SA ENERGY TRANSFORMATION: RIVERLINK RIT-T
AUGUST 2018

South Australian Energy Transformation
PADR Feedback
31 August 2018

The Project Assessment Draft Report

Figure 2 NEM coal-fired generation fleet operating life to 2040, by 50th year from full operation or announced retirement

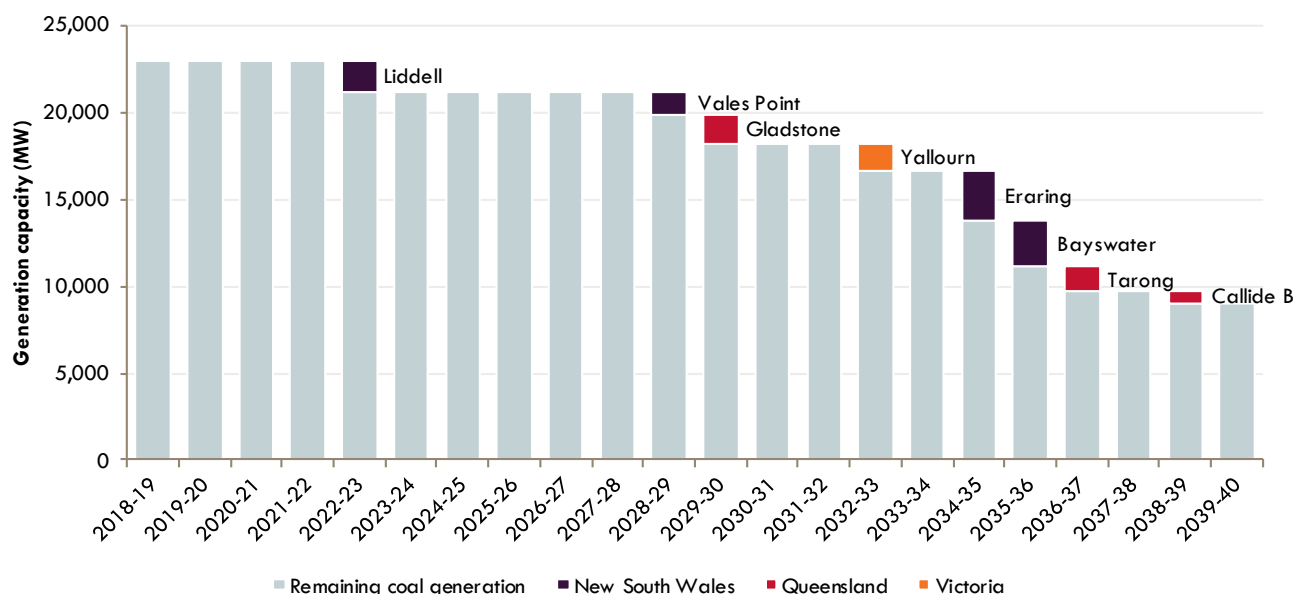
A fundamental assumption of the PADR seems to rely on the NSW region being in a state of “oversupply”, especially with the type of asset required to provide “firming” of variable generation in both South Australia and those assumed to be developed in the Renewable Energy Zones (REZ’s) the project dissects. Yet according to the AEMO ISP, two NSW based coal fired assets in Liddell (in 2022) and Vales Point (2028) are assumed to retire removing some 3,320 MW of the type of dispatchable generation that is required in both NSW and SA.

While you can also assume that other “resources” enter the market, the current trend is for a majority of these to come from distributed generation sources that also have a level of variability. With the National Energy Guarantee now put into suspended animation and with it the Reliability Guarantee that could have played an important role of integrating variable generation and deployment more dispatchable resources, the unpredictability of the system is only set to get worse.

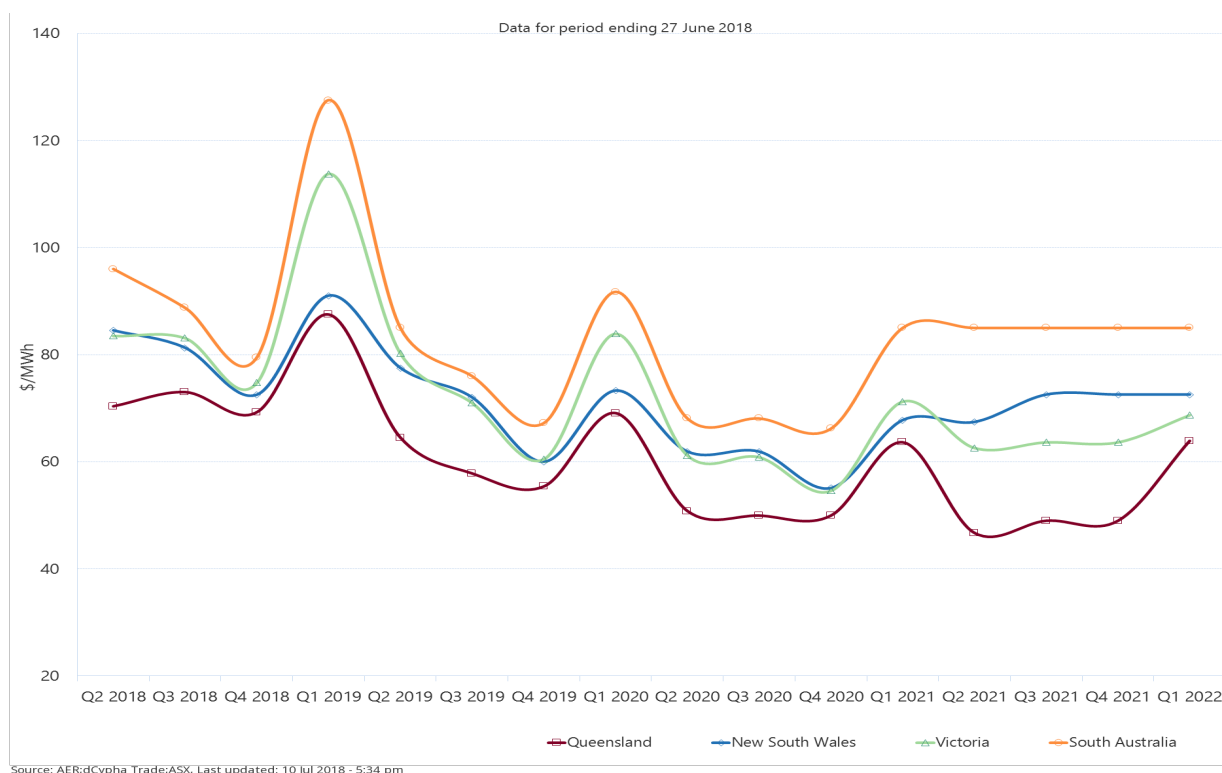
The PADR also assumes that 800 MW of gas fired generation retires in SA (2024) and a further 63 MW of generation fired by liquid fuels retires in 2027. The capacity of which largely mirrors the capacity of the project itself raising concerns that rather than the project increasing liquidity in the SA market, it merely replaces it with capacity from NSW, a market which in itself will become much “tighter” in the coming decade.

This is important to understand as the key driver of consumer benefits of the project is lower fuel costs by the removal of expensive gas and liquid fuels, to be replaced by “cheaper” black coal generation from NSW. Given retirements of dispatchable generation in both regions, the long-term MWh price spread, relied upon so deeply by the proponents, may not be as wide as anticipated and therefore the consumer price benefit may not materialise.

We note that the latest AER Quarterly 2022 base futures price for NSW is in the order of \$75 MWh while in SA it is in the order of \$82 MWh.
